**PLANNING & DEVELOPMENT**  
**CITY OF NEWARK**

The following are the Subdivision Advisory Committee comments for the Proposed Rezoning, Special Use Permit, Comprehensive Development Plan Amendment, and Major Subdivision Plan for 339, 341, & 349 East Main Street, Project PR#21-08-02.

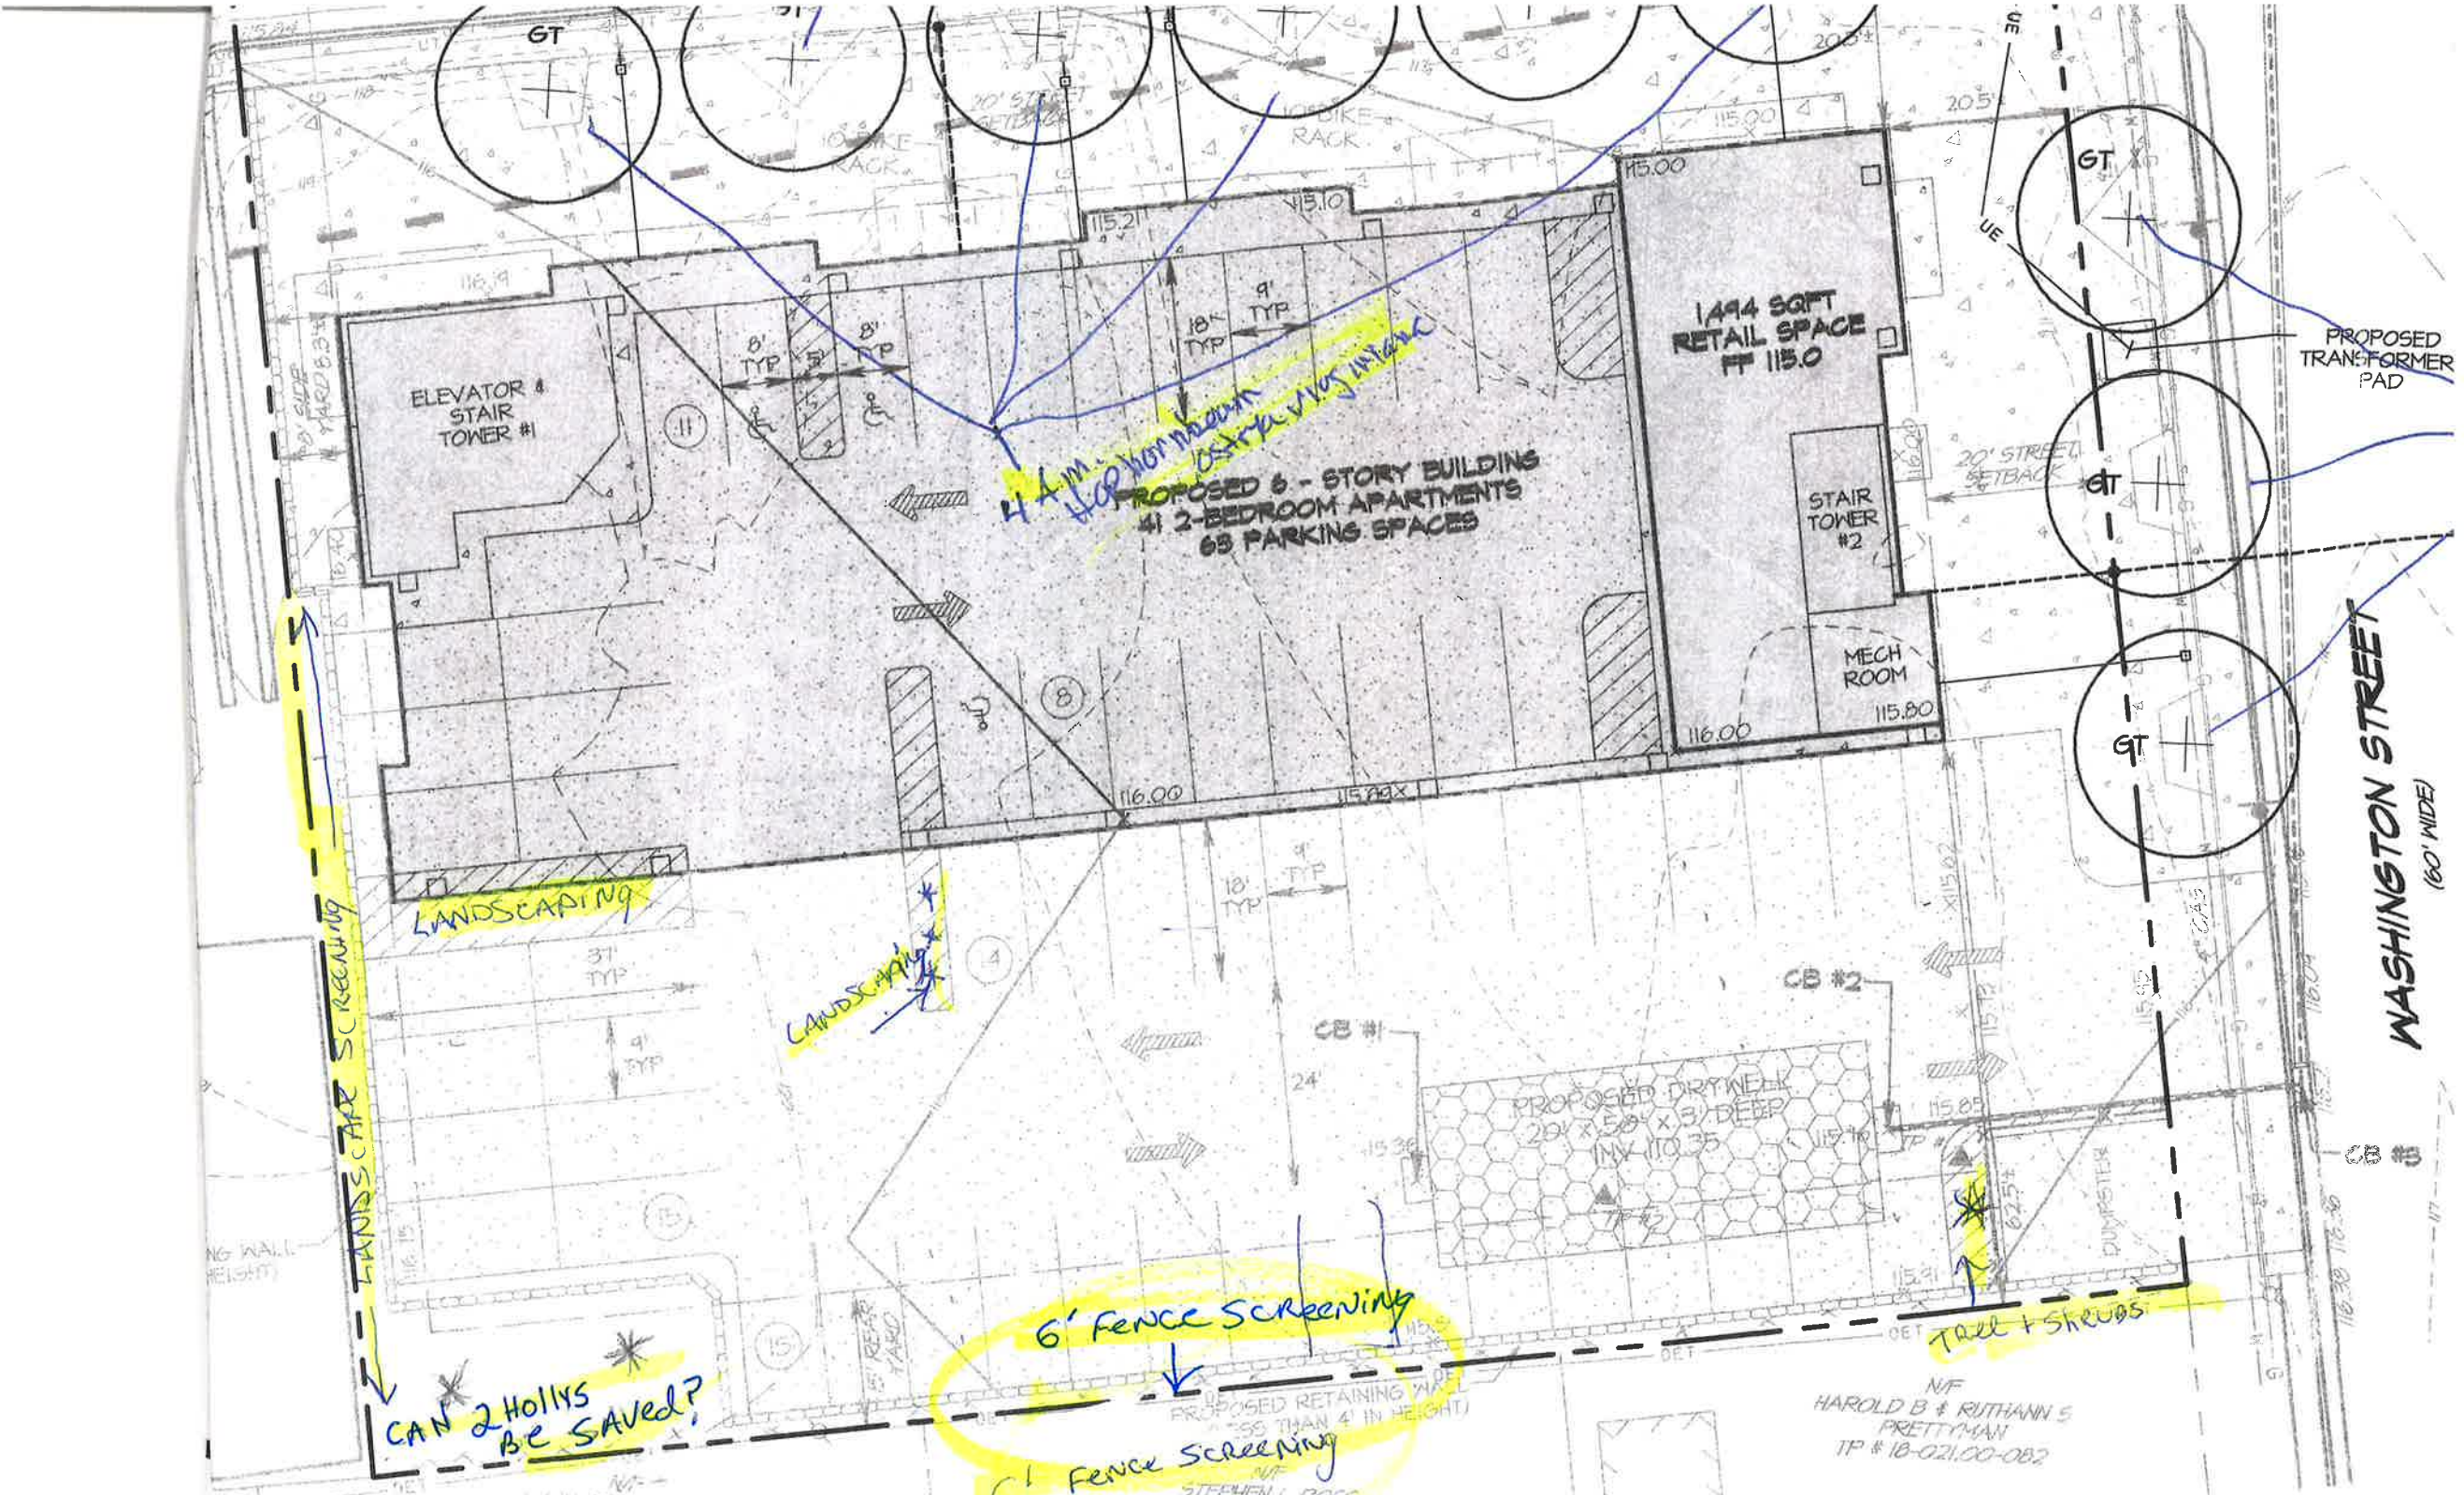
1. On sheet #2 on the SW corner of the site are 4 "evergreen" symbols noted. If the proposed retaining wall goes in as shown on the plan, the back 2 American Hollies might be able to be saved and remain as part of the plan. If this is the case, then a tree protection zone will be needed at least out past the drip lines as much as construction will allow. If the two hollies can not be saved the area will be required to have landscaping installed including two trees.

3. The parking lot has no landscaping shown on the plan or screening. We have written some notes on the attached where landscaping can be installed including;

- Landscape screening along the west side of the building behind the retaining wall.
  - In parking area where the crossed hatched no parking areas are located, low growing shrubs and perennials can be added such as coraldrift roses, diervilla, Japanese holly, winterberry, plum bago, coreopsis,

- In the area behind the dumpster fence a columnar tree with shrubs can be planted such as dawyck purple beech, columnar sergeants cherry, spirea, amagowa cherry

4. Along the rear of the property we will require a 6' fence for screening behind the retaining wall.
5. We have the value tree mapping for the property of all trees with the DBH of 12" or greater. After our inspection of the value trees listed, several trees indicated as value trees had structural flaws or are in decline and will not be counted as value trees. There are still approximately 11 value trees remaining that will be included in value tree replacement as per Chapter 32, Article XXV – Landscape Screening and Treatment, 32-87(g) General provisions, definitions and tree mapping requirements.
6. We would be happy to meet with Hillcrest to discuss the value tree listing and mitigation requirements.

LANDSCAPING

LANDSCAPING

6' Fence Screening

6' Fence Screening

CAN 2 HOLLYS BE SAVED?
